Access Compliance Report

Public Rights-of-Way

(Curb Ramps)

Intersection ID: 10034609	Main Street: PLANTATION_CENTER_DR	Cross Street: N/A	Location: N
ADA ID: 36656EAF316	Ramp Type: Para	Initial Pass/Fail: Fail	Overall Compliance: No
Codes/Mitigation Info/Possible Solution		Field Measurements/Component Compliance	
Severity Score: 12.5

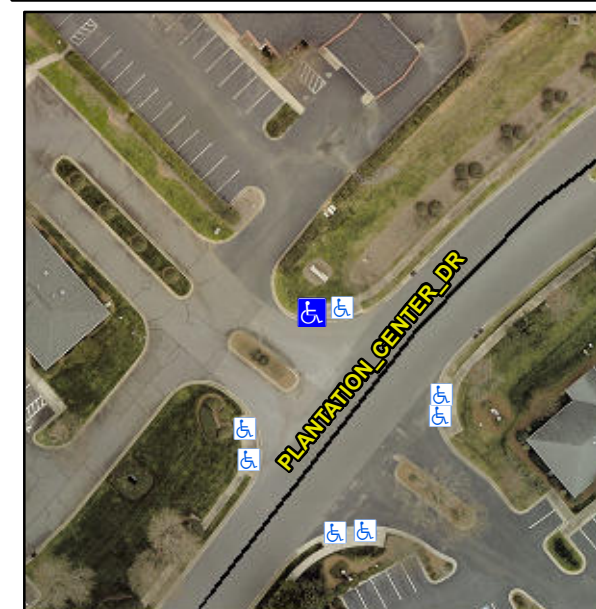
R304.3.2

Compliance	Description	Data	Compliance	Description	Data
N/A	Ramp Length LT (in)	60.0	N/A	Ramp Length RT (in)	60.0
Yes	Ramp Width LT (in)	96.0	Yes	Ramp Width RT (in)	96.0
No	Ramp Slope LT (%)	8.6	Yes	Ramp Slope RT (%)	5.9
Yes	Ramp XSlope LT (%)	2.0	Yes	Ramp XSlope RT (%)	1.6
N/A	Landing Length (in)	N/A	N/A	DWS Provided?	N/A
N/A	Landing Width (in)	N/A	N/A	DWS Contrast?	N/A
N/A	Landing Slope (%)	N/A	N/A	DWS Length (in)	N/A
N/A	Landing X Slope (%)	N/A	N/A	DWS Full Width?	N/A
N/A	Landing Curb? (Y/N)	N/A	N/A	DWS Offset (in)	N/A
N/A	Shared Landing?	N/A			
N/A	Gutter Ponding?	N/A	N/A	Gutter Slope (%)	N/A
N/A	Gutter Lip Ht (in)	N/A	N/A	Gutter X Slope (%)	N/A
N/A	Painted X Walk1?	No	N/A	Painted X Walk2?	N/A
	X Walk 1 Direction	To SW		X Walk 2 Direction	N/A
N/A	X Walk 1 Width (in)	N/A	N/A	X Walk 2 Width (in)	N/A
	X Walk 1 Slope (%)	1.8		X Walk 2 Slope (%)	N/A
	X Walk 1 X Slope (%)	0.1		X Walk 2 X Slope (%)	N/A
N/A	Ramp inside XWalk1?	N/A	N/A	Ramp inside XWalk2?	N/A

Remove & Replace Entire Ramp.
